United States Patent and Trademark Office

APPLICATION NO.	APPLICATION NO. FILING DATE		FIRST NAMED INVENTOR	ATTORNEY DOCKET NO.	CONFIRMATION NO.
10/718,154		11/20/2003	Pierre Nobs	36240	9002
116	7590 01/05/2006			EXAMINER	
PEARNE & GORDON LLP 1801 EAST 9TH STREET				KAYES, SEAN PHILLIP	
SUITE 1200		CC1		ART UNIT	PAPER NUMBER
CLEVELA	VD. OH	44114-3108	2841

DETAILED ACTION

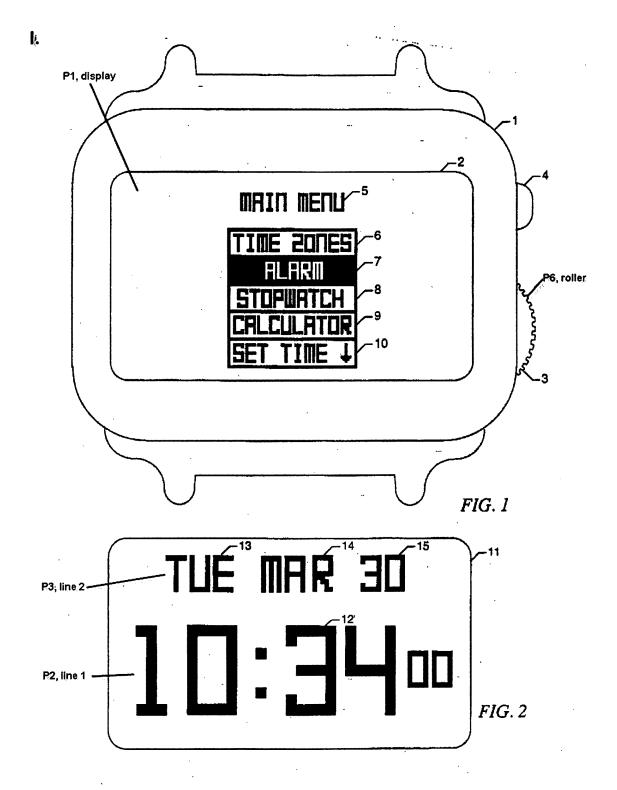
- 7. Claims 1-13, and 15 are rejected under 35 U.S.C. 102(b) as being anticipated by Will (US 5477508.)
- 8. With respect to claim 1 Will discloses a digital watch, comprising a digital display (P1, picture I.), said display comprising a first line of alphanumeric characters (P2) and a second line of alphanumeric characters (P3), said watch further comprising control means (microprocessor 20, figure 3a, also shown in picture II. as P4) for keeping and displaying the current time on said digital display and an interface device (P5, picture III.) sensitive to axial pressure and to rotation around its axis and connected to said control means (Interface device is sensitive to axial pressure resulting from rotation, rotation, and linear pressure. Linear pressure exerted on device axial is translated to sensor P10.)

- 11. With respect to claim 4 Will discloses the digital watch according to claim 2, wherein said functions comprise a standard display mode and at least one additional mode from among: calendar (displayed on line 2, P3, of picture I.), alarm (7, picture I.), countdown, second time zone (6, picture I.) and chronograph (8, picture I.).

- 12. With respect to claim 5 Will discloses the digital watch according to claim 4, comprising at least one time zone function (6, picture I.) for keeping and displaying the time of an auxiliary time zone and the time of a main time zone, wherein said time zone function comprises a second display option wherein said time of an auxiliary time zone is displayed on said first line of alphanumeric

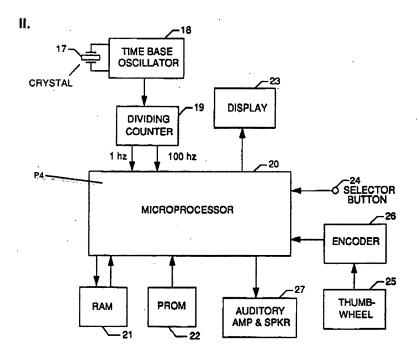
- 14. With respect to claim 7 Will discloses the digital watch according to claim 1, wherein said control means (P5, picture II.) are capable of discriminating between a short pressure and a prolonged pressure on said interface device (a microprocessor is capable of distinguishing between a long duration signal from a sensor and a short duration signal from a sensor.)

111.

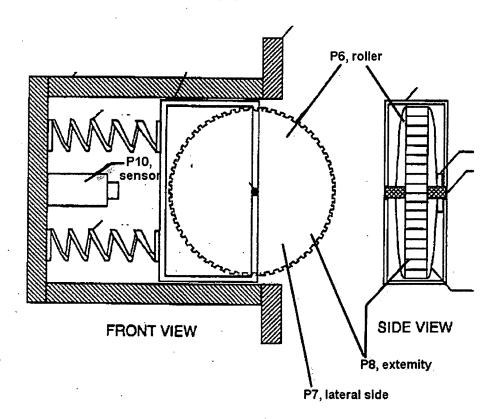
- 10. With respect to claim 3 Will discloses the digital watch according to claim 1, wherein said interface device is a roller (P6, picture III.) fastened on the face side of said watch, so as to be capable of turning around its axis, said roller having at least one sector of its lateral surface (P7) accessible for allowing a rotation to be communicated with a finger tip, said roller (P6) having an extremity (P8) accessible for allowing an axial pressure to be exerted with a finger tip.

- 17. With respect to claim 10 Will discloses the method according to claim 9, wherein at least one of said operating modes comprises a subsidiary definition mode and reacts to pressure exerted on said interface device (P5) by activating said subsidiary definition mode (figure 11e and 11f show an operating mode with a subsidiary definition mode and figure 6 shows an embodiment wherein interface device 36, P5 picture III, is the only means of input/selection.)
